Livestock Plaza/Sheep Barn

Addendum Issue Date: 8/8/24

The following changes, revisions, or clarifications shall be made to the drawing documents.:

FULL SCALE: 22x34
HALF SCALE: 11x17
DRAWING MAY NOT BE
PRINTED TO SCALE

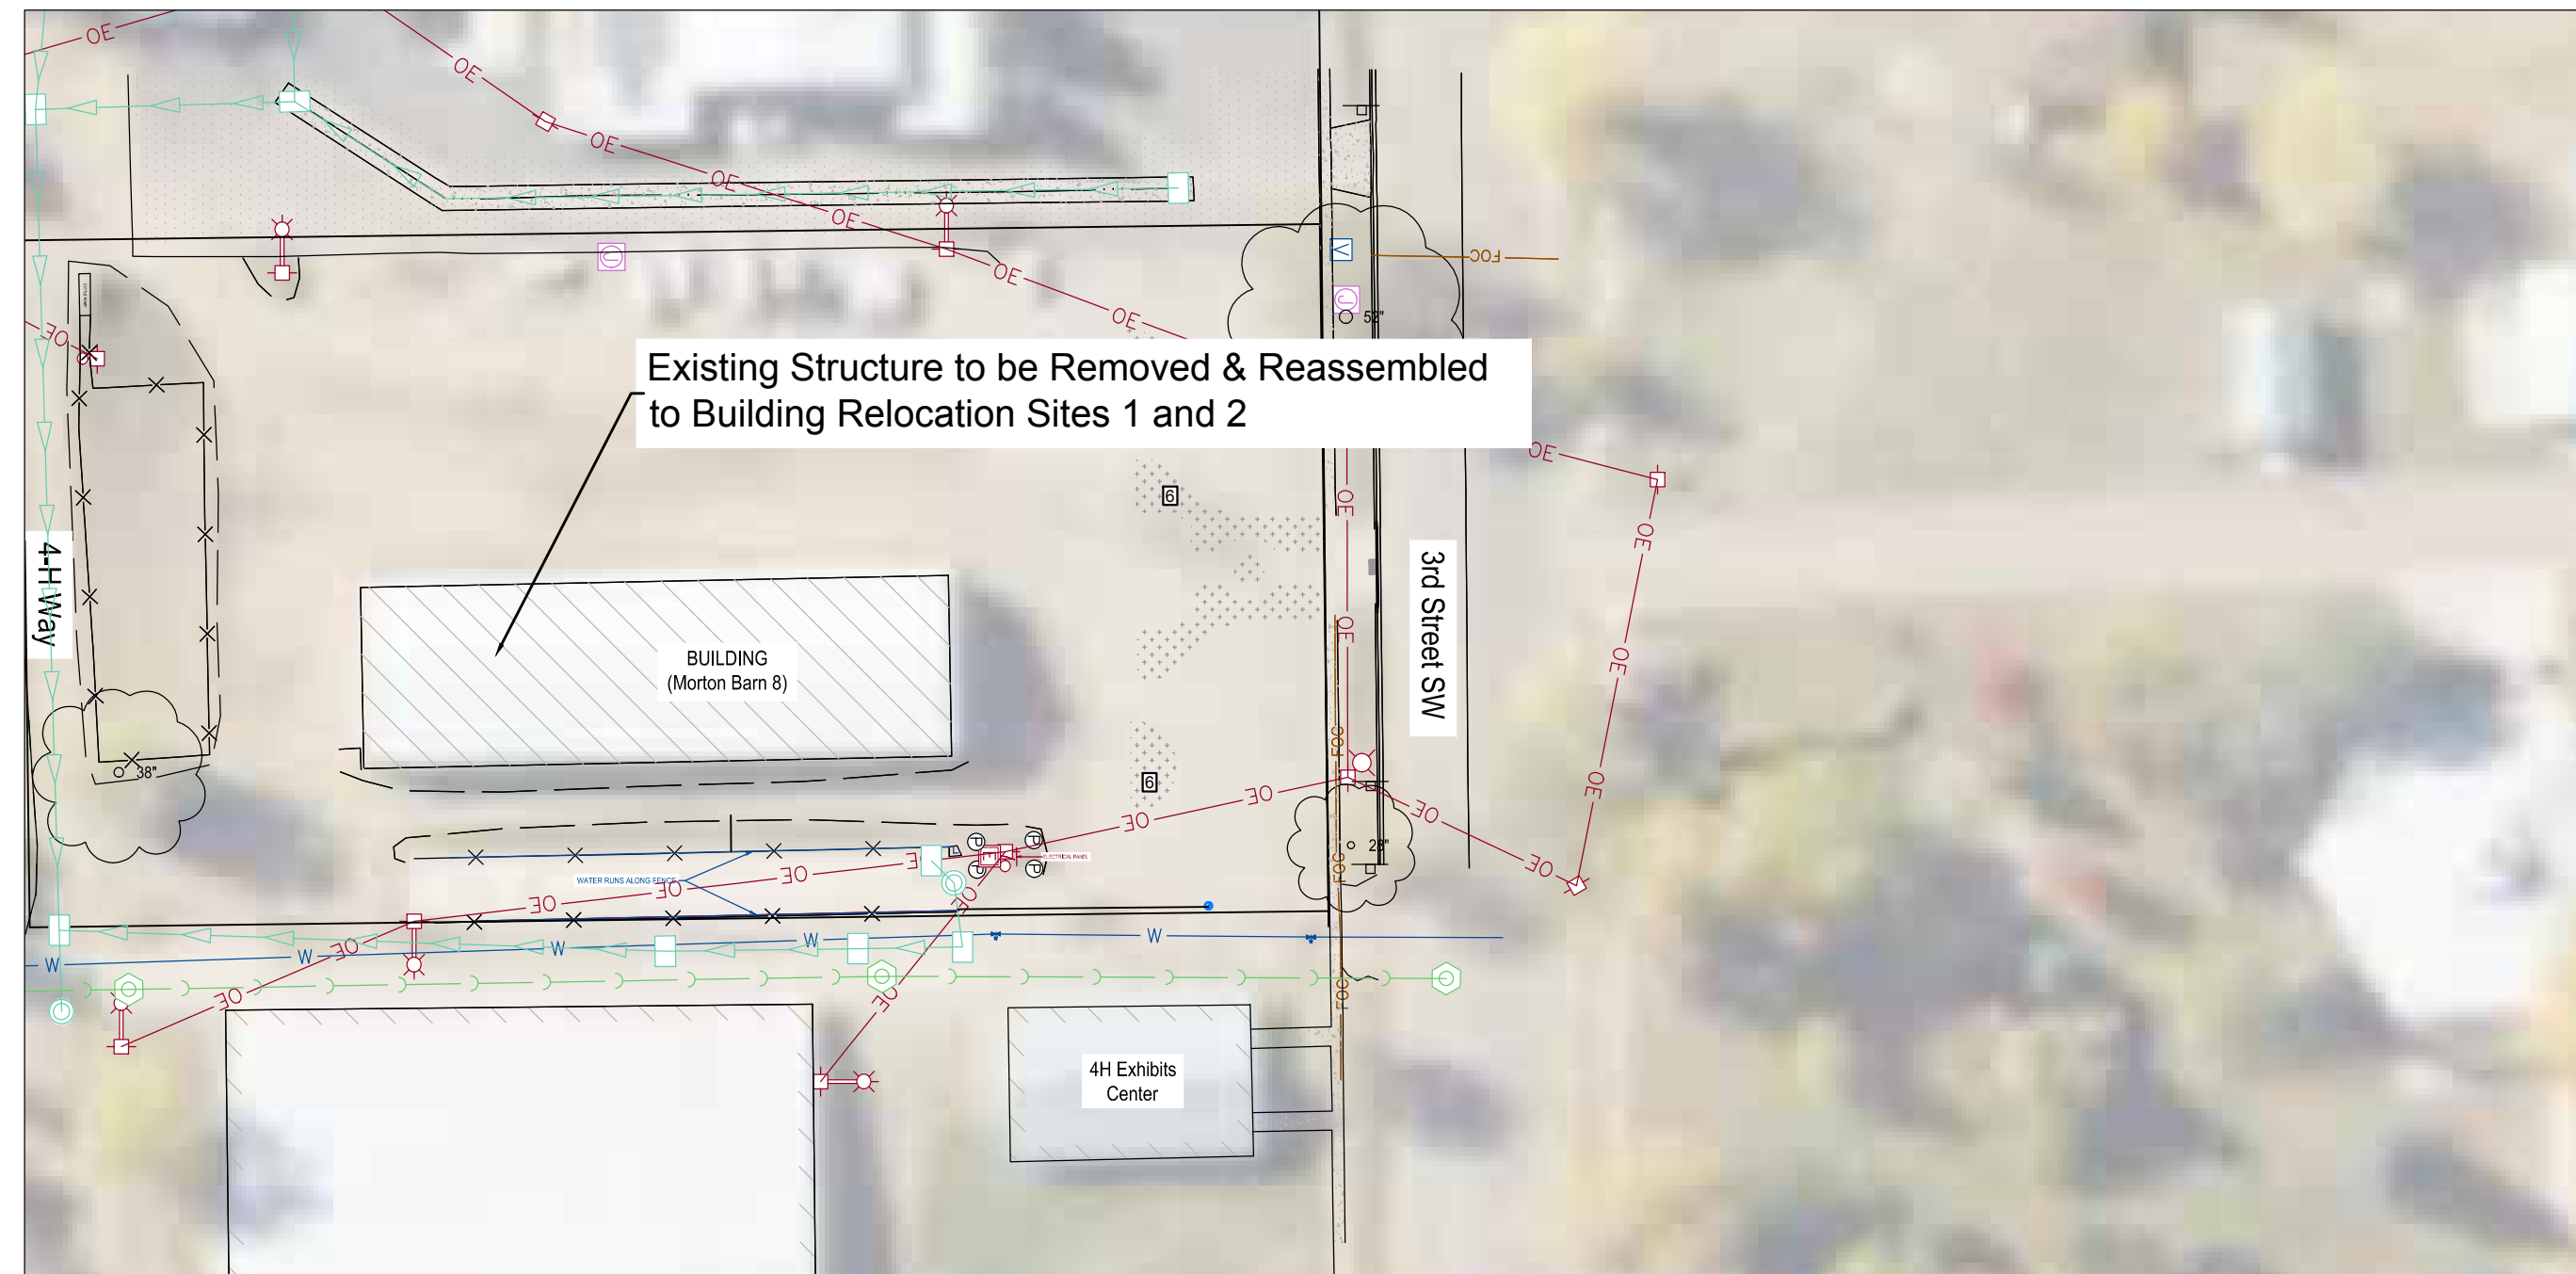
R-C1.1 - Building Relocation Site Plan

- Added Notes & Typical Sections for Building Relocation Sites

A3.2

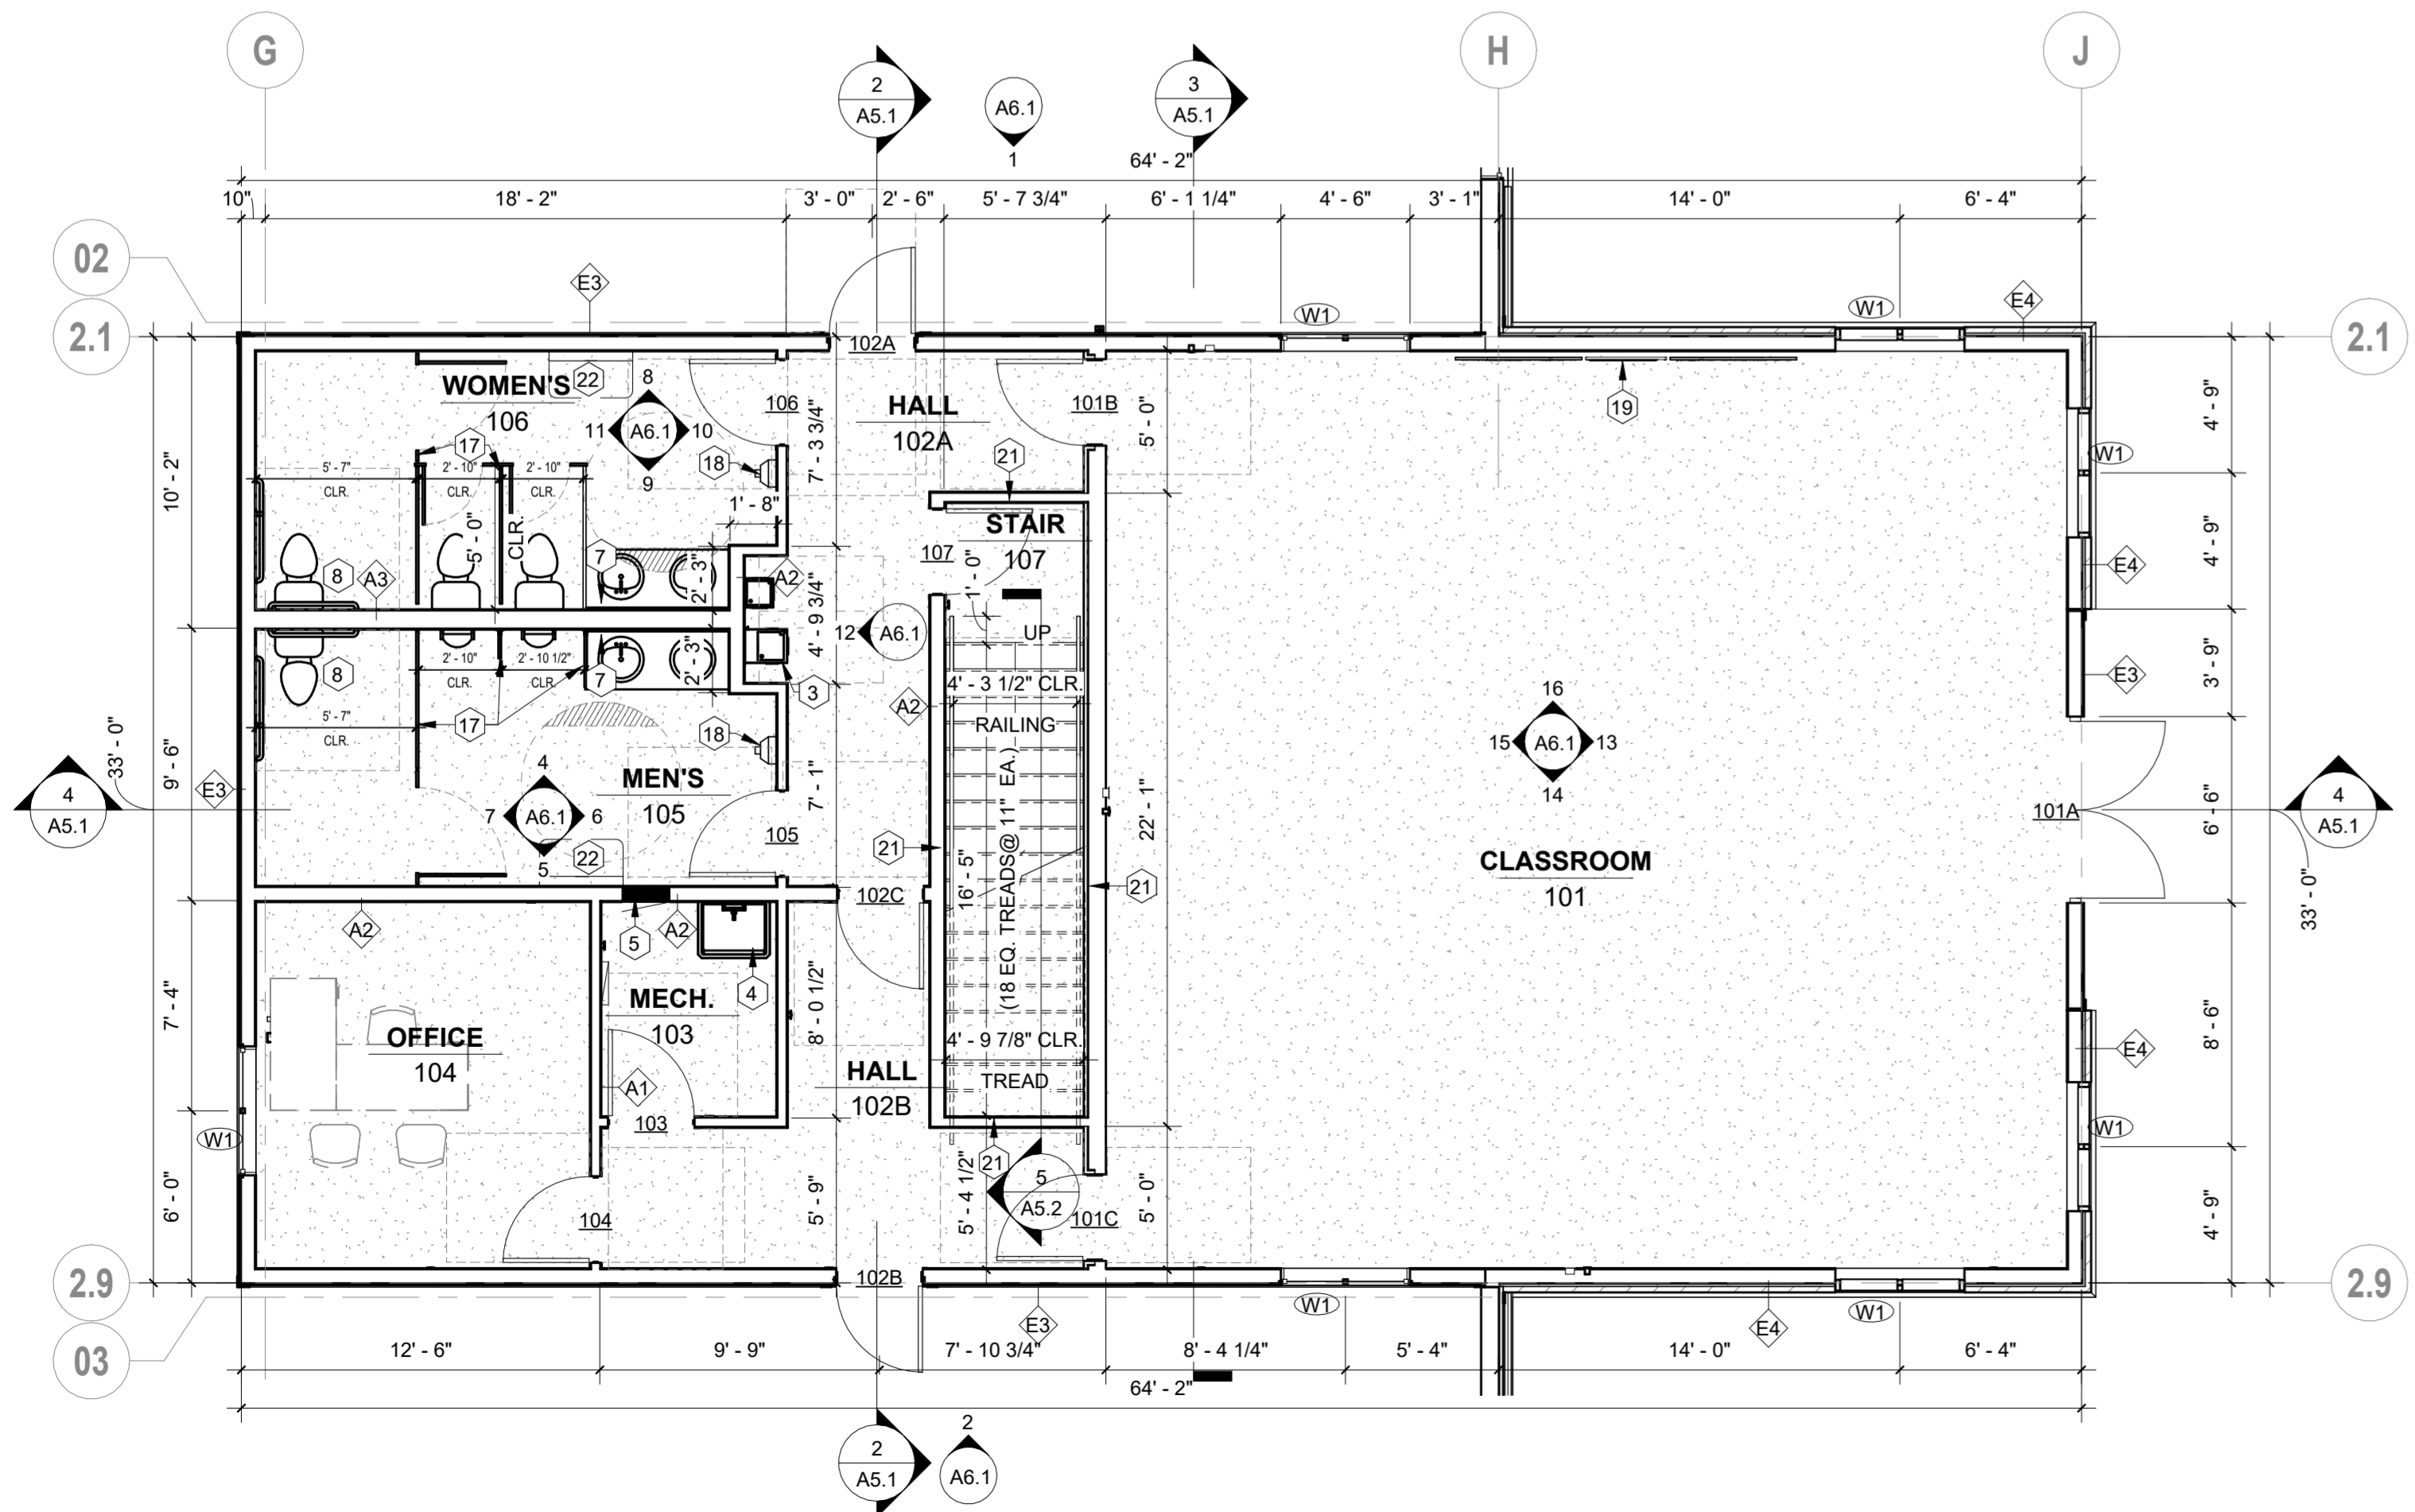
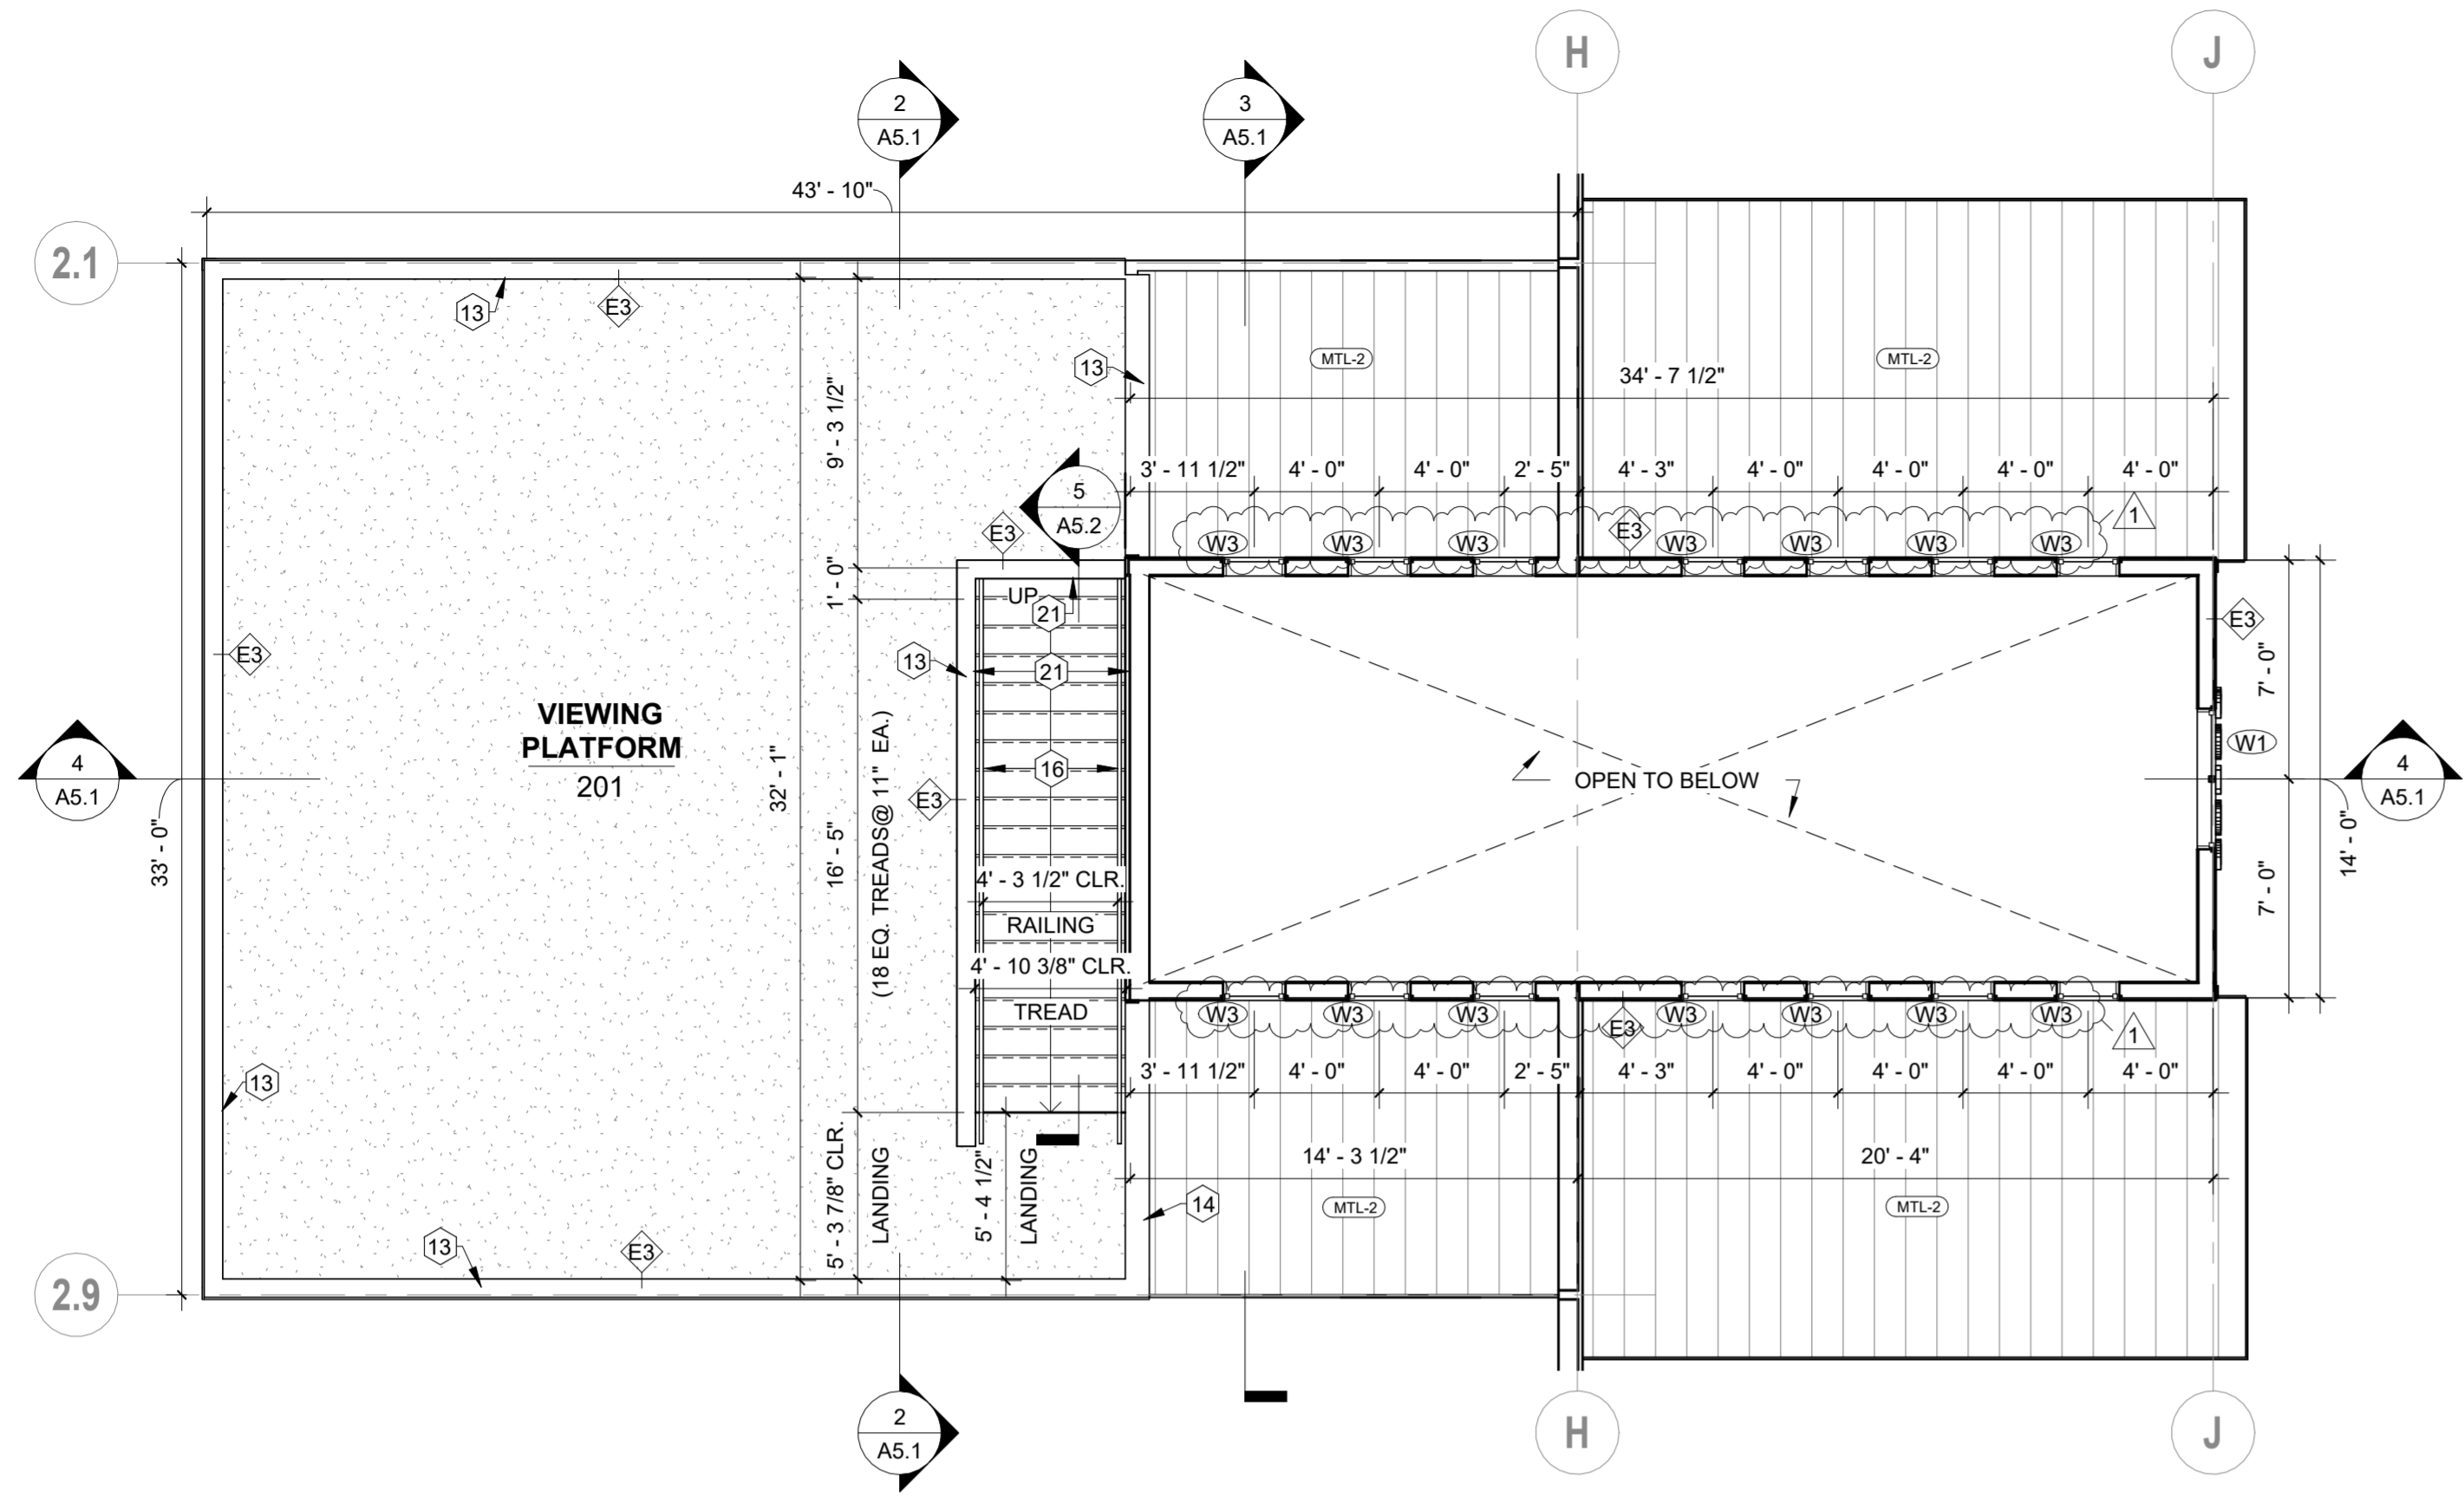
Sheet A3.2 - Enlarged Plans:

Keynote 19 revised.
